Memorandum

To:	Tiberius (Holroyd) Pty Ltd	Date:	29 September 2025
Attention:	Lucas Flecha	Project No.:	84770.07
Email:	lucas.flecha@acequity.com.au	Reference:	R.001.Rev1
Subject:	Groundwater Statement - Proposed Mixed-Use Precinct 1 Crescent Street, Holroyd

At the request of Tiberius (Holroyd) Pty Ltd, Douglas has prepared this memorandum in response to NSW DCCEE¹ letter attached (Ref.: OUT25/3167, dated 18 March 2025) in relation to the estimated annual volume of groundwater take due to aquifer interference activities during the development and service life of the proposed mixed-use precinct.

Figure 1: Overall Lower Ground Floor Plan (W-B, 121784, CP-AR-0-12LG E)

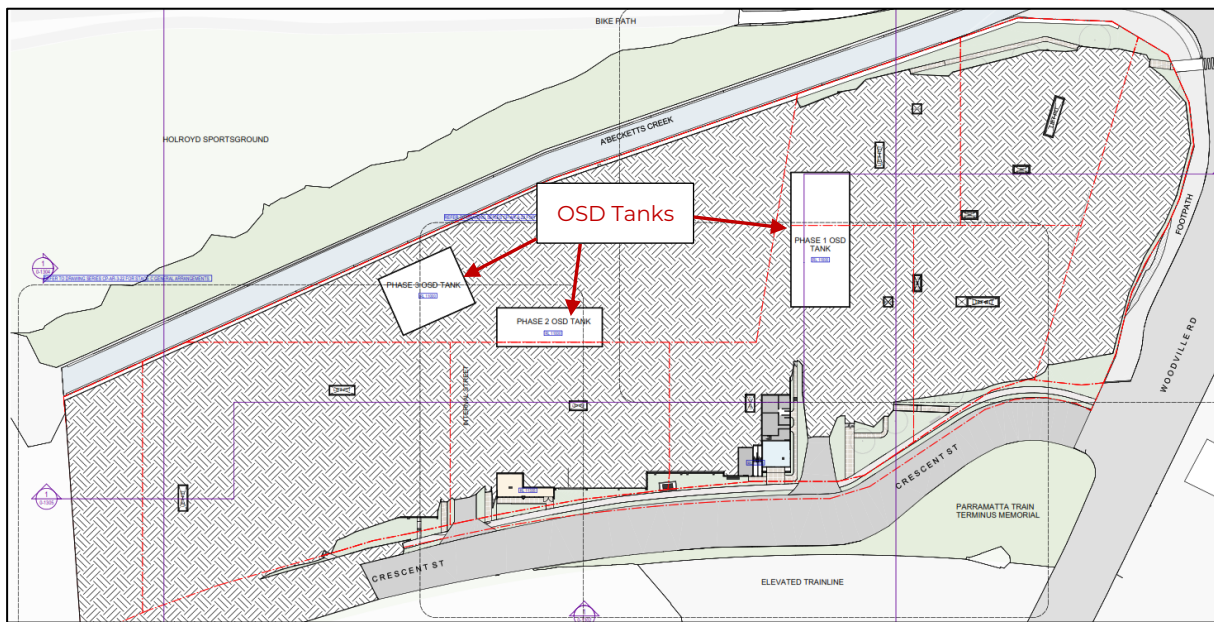
No.	Issue Raised	Refer to Section
DCCEEW-1	Water supply, take and licensing Recommendation - Pre-determination That the proponent quantifies the maximum annual volume of water take due to aquifer interference activities and demonstrates the ability to acquire sufficient water entitlement unless an exemption applies. Explanation Insufficient information has been provided to confirm the potential groundwater inflow volumes. NSW DCCEEW Water Group notes that the groundwater table will potentially be intercepted. Maximum excavation depths for this project are up to 1.5m. The quoted data indicate that groundwater will be deeper than the deepest excavation, however there is commentary regarding seepage while piling and seepage of perched groundwater. The proponent has not presented sufficient information and analysis on inflows during the construction and ongoing operation of the site. Quantification of maximum potential inflow volumes is required.	Sections 4 & 5

DCCEEW-3	Groundwater impacts and dewatering requirements Recommendation - Pre-determination If the take of groundwater is found to be greater than 3 ML per year, the proponent must assess the impacts due to aquifer interference activities in accordance with the NSW Aquifer Interference Policy and framework (2012). These documents are available at: https://water.dpie.nsw.gov.au/_data/assets/pdf_file/0005/151772/NSW-Aquifer-Interference-Policy.pdf https://water.dpie.nsw.gov.au/_data/assets/pdf_file/0007/171097/Aquifer-Interference-Assessment-Framework.pdf Explanation Although groundwater take is not anticipated to be significant, as per Recommendation 1.1 above, the EIS has not provided a volumetric quantification of groundwater take. Additionally, the EIS has not provided an assessment of impacts to groundwater due to construction or operation of the project. Although a comprehensive groundwater study prior to determination is unnecessary given the perceived low level of risk, NSW DCCEEW Water Group notes that without groundwater take estimations it is difficult to assess	Section 5

the level of risk. Therefore, the proponent should determine the estimated take volume.	
DPHI-B-20	Confirm the maximum annual volume of water take, demonstrate sufficient water entitlement and assess the proposal against the Aquifer Interface Policy and Framework 2019 (if applicable).	Section 5

The overall lower ground plan is shown in Figure 1. This figure also shows the location of proposed OSD tanks and lift pits across the footprint of the development. It is understood that the lowest levels of the proposed OSD tanks and lift pits are designed at RL 11.0 m AHD and RL 9.8 m AHD respectively. Other minor and localised excavations for services trenches and pile caps are expected.

Minor bulk excavations would be required at localised areas for site preparation and level grading. Deeper localised excavations for the proposed lift pits and three OSD tanks will be required, which are expected to be limited to 3 m depth (approximately).

The deepest proposed excavations for the development are localised to the OSD tanks and lift pits (which will ultimately be tanked water-tight structures). The average groundwater levels are mostly below the designed levels for the proposed OSD tanks and lift pits, and the risk of significant water seepage during the bulk and localised excavations due to aquifer interference is considered to be negligible. Any seepage during construction is expected to be manageable by sump and pump methods.

The qualitative assessment of the proposed development in relation to the available results of groundwater measurements and the existing subsurface profile suggest that the total groundwater take during the construction for the entire site to be relatively minor and well below 3ML/year. Therefore, it is understood that the development may benefit from the Water Access License exemption, subject to DCEEW approval. Permanent dewatering will not be required.
